# Modification Recommended Service Note

## Keysight i3070 Series 6 In-Circuit Test System

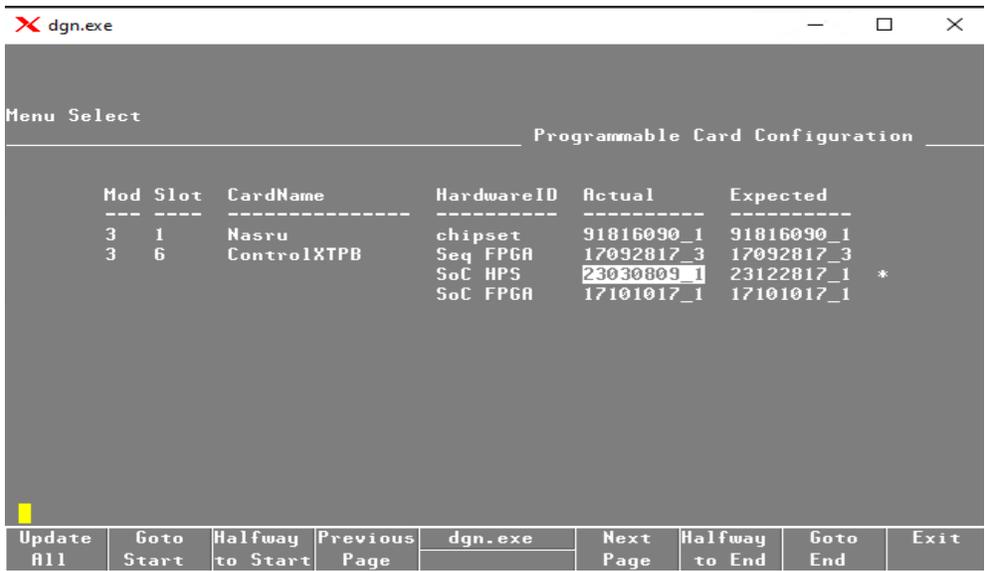
- 1. Download the latest firmware update file (XTPB\_SoC\_HPS\_Mux.img) from [Keysight i3070 Control XTPB card firmware update | Keysight](#)
- 2. Copy the file to C:\i3070\_ICT\lib folder in the i3070 system controller after renaming the original file there.
- 3. Launch DGN.
- 4. Select Configuration > Programmable Card Config.
- 5. Any available firmware updates will be highlighted as shown below:

6. Select Configuration > Programmable Card Config.
7. Select "Update All" to begin the update.
8. Whenever the User Account Control dialog box appears, select "Yes" to allow the system to proceed.
9. When installation is completed, reboot the testhead.
